AMENDMENTS OF THE DRAWINGS

The attached two (2) replacement sheets of amended drawings and two (2) annotated sheets include changes to FIGS. 1A, 1B, and 3. The replacement sheets (1/7) and (3/7) should replace sheets (1/7) and (3/7), as originally filed and as presented in the formal drawings filed June 30, 2004. In the amended drawings filed herewith, the following amendments have been made which are also indicated on the annotated drawings also filed herewith:

FIG. 1A
(PRIOR ART)

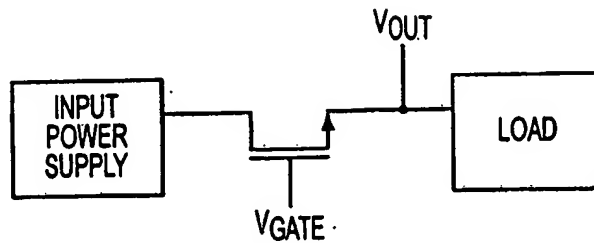
(1) FIGS. 1A and 1B have been labeled as "PRIOR ART" as suggested by the Examiner in the pending Office action; and

The Examiner objected to FIGS. 1A-1B and 2A-2D for not being designated as "Prior Art."

Applicant has amended FIGS. 1A and 1B to provide "Prior Art" designations. Accordingly, applicant respectfully requests that the objection to FIGS. 1A-1B be withdrawn.

FIG. 3

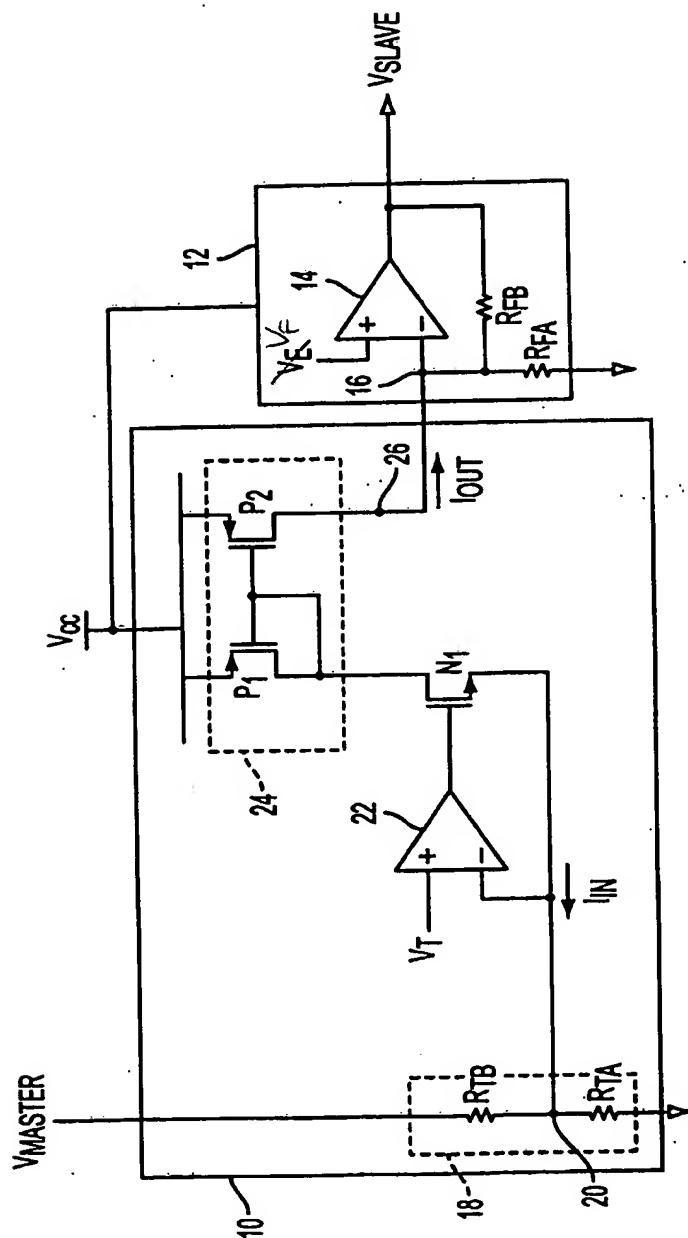
(2) the signal transmitted to the non-inverting input of amplifier 14 in FIG. 3 has been changed from " V_E " to " V_F " in accordance with the specification at page 6, lines 16-20.

The Examiner objected to the specification and to FIG. 3 for containing various informalities.

Applicant also has amended FIG. 3 so that the signal transmitted to the non-inverting input of amplifier 14 now recites " V_F " (rather than " V_E ") in accordance with the specification at page 6, lines 16-20.
